**Advisory Action
Before the Filing of an Appeal Brief**

09/871,199

KAIN, JAMES M.

Diagram A - Annotated Figure 1 of Mitchell

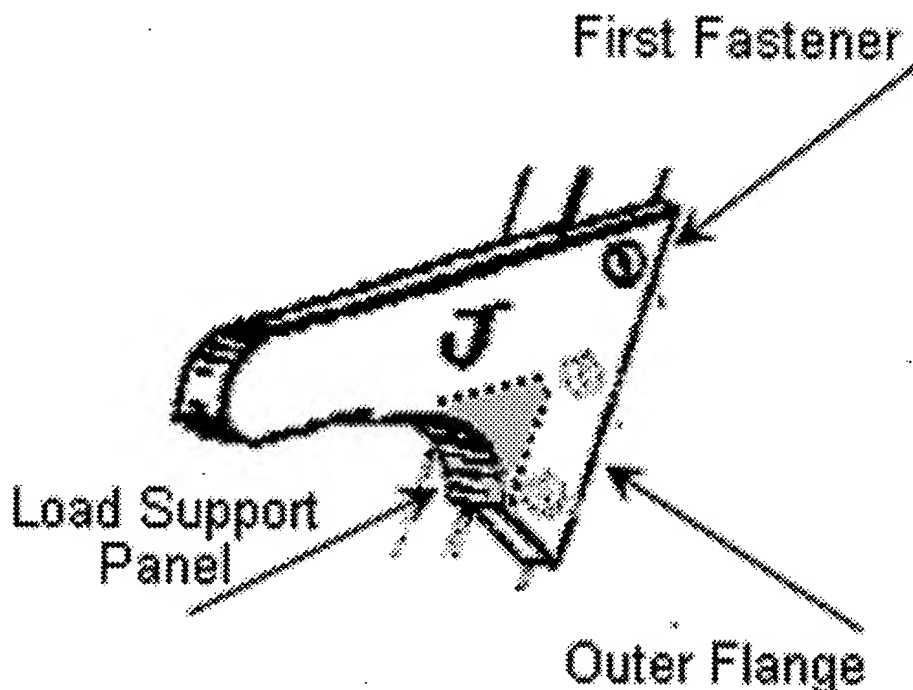
With respect to the armrest of Mitchell, Applicant appears to not understand the teachings of Mitchell. The armrest of Mitchell has a first fastener (see Diagram A below) and a load support panel that engages a ridge of the seat back to block pivotable movement of the armrest downward about a pivot axis established by the first fastener. See the previous Office Action for motivation to further modify the seat assembly of Lemmeyer et al. Diagram A sets forth the relationship of the load support panel and the flanged wings of the armrest such that the combination regarding claims 13 and 25 is apparent.
